P 523487

A ~~REPAIR~~ upgrade

ON-SITE SEWAGE DISPOSAL SYSTEM HOWARD COUNTY HEALTH DEPARTMENT BUREAU OF ENVIRONMENTAL HEALTH

ADDRESS: 3813 Ivory Road PHONE NUMBER: _____

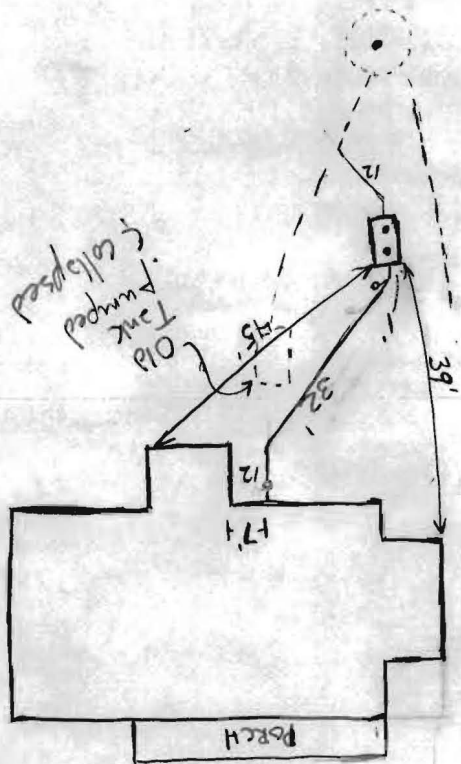
TRENCHES:	Trench to be _____ feet wide. Inlet _____ feet below original grade. Bottom maximum depth _____ feet below original grade. Effective area begins at _____ feet below original grade. _____ feet of stone below distribution pipe.
LOCATION:	<u>Tank Depth not to exceed 3' deep</u>
PURPOSE:	Moving septic tank to accommodate building permit for deck. Call for inspection when ground is opened so sanitarian can recommend repair.

PRE-CONSTRUCTION 5/11/06 New Septic tank installed.
Lines tied in, OK to cover. Old Tank pumped & collapsed

INSTALLATION OK for Deck BP!

LOCATION
MORTGAGE
SURVEY

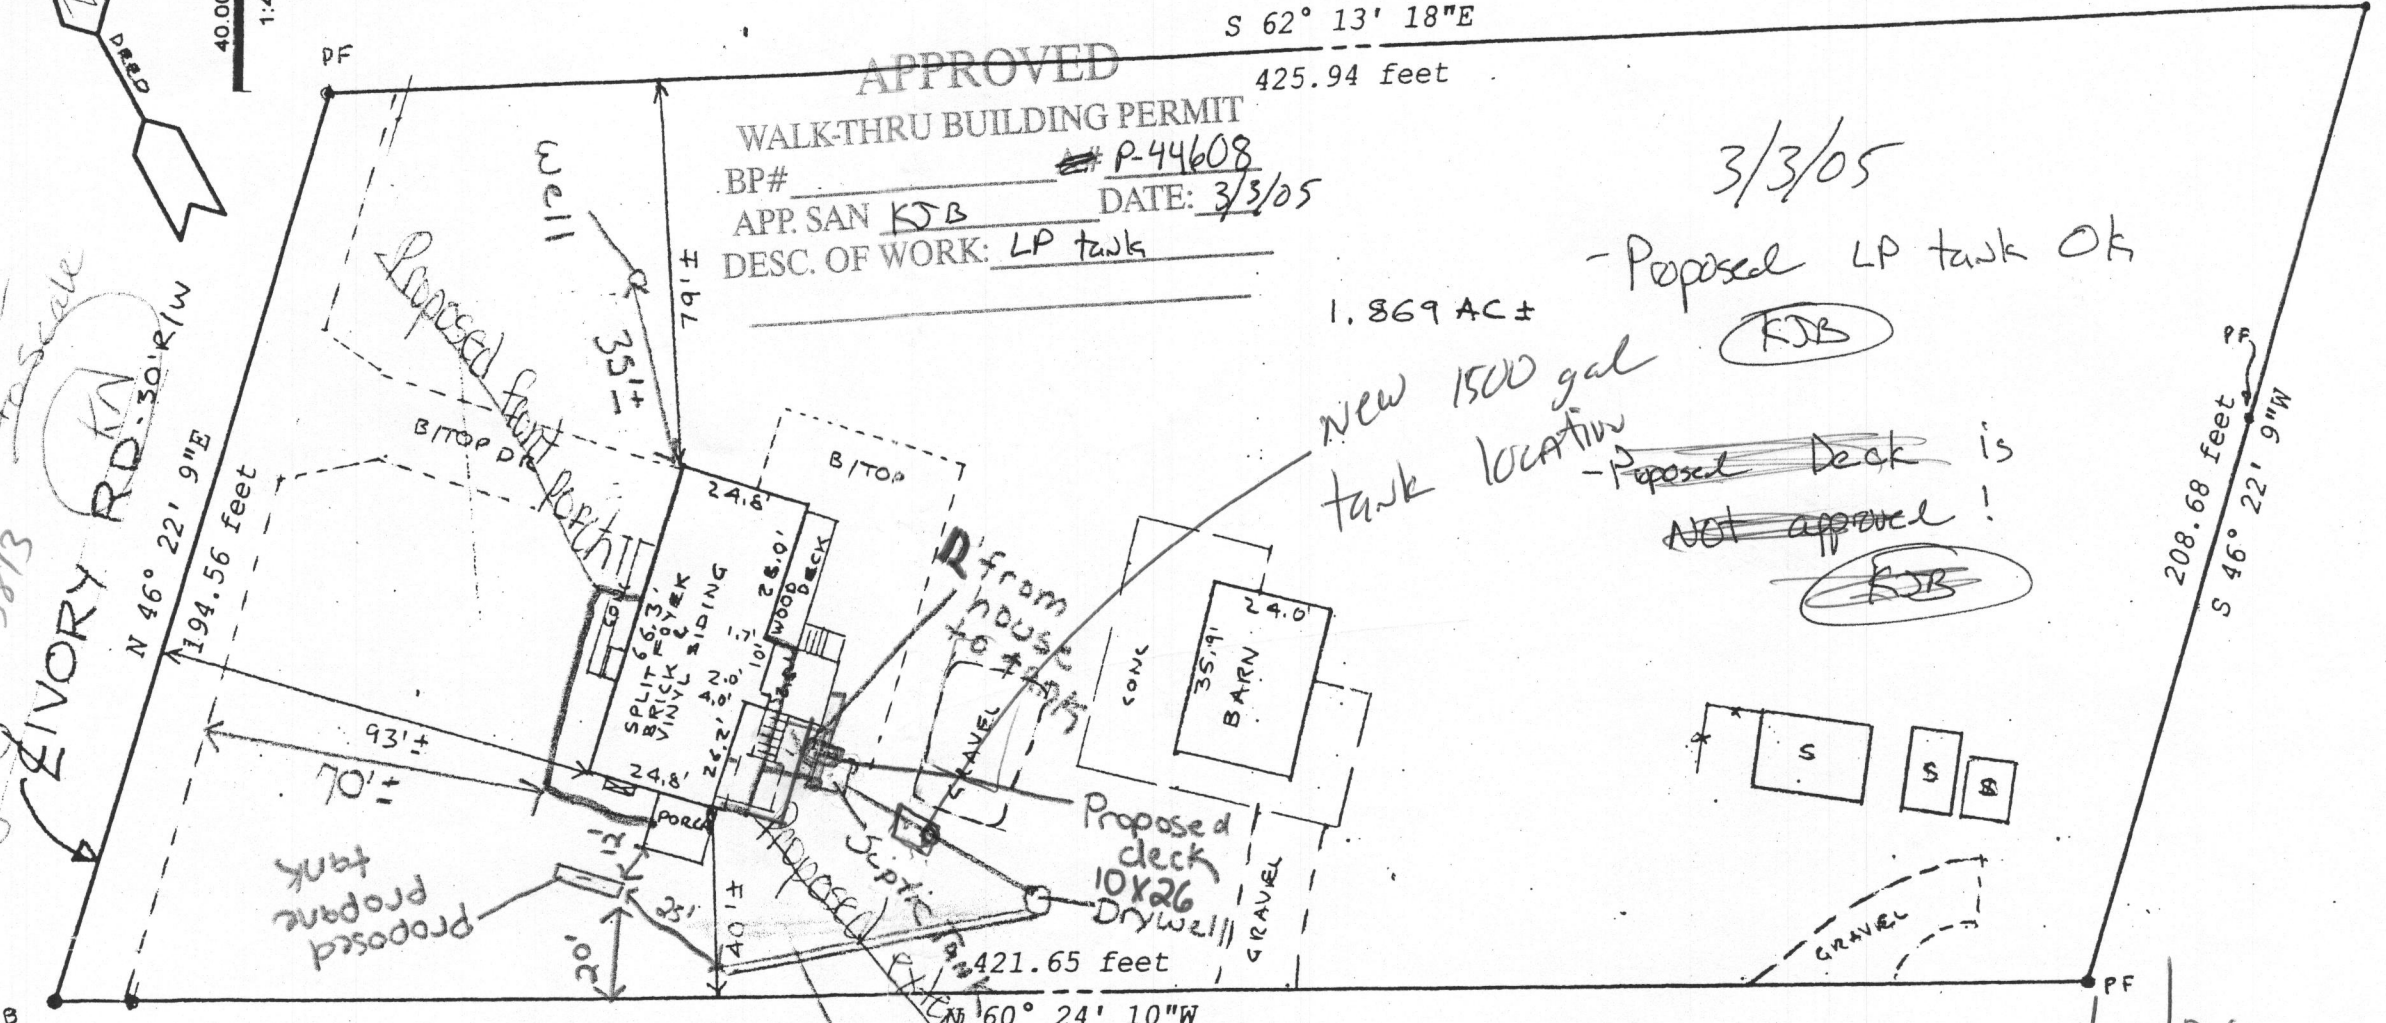
10-25-04
NEED EXACT
MEASUREMENT
FROM PROPOSED
EXTENSION TO
S.T.
Well??

1.869 AC ±
New 1500 gal tank location
- Proposed LP tank OK
KJB
- Proposed Deck is NOT approved!
KJB

10-27-04
Well and septic setbacks met

Drain field 65' long
6' of gravel

5/11/06
Deck proposal OK. Septic tank Moved.
GAC
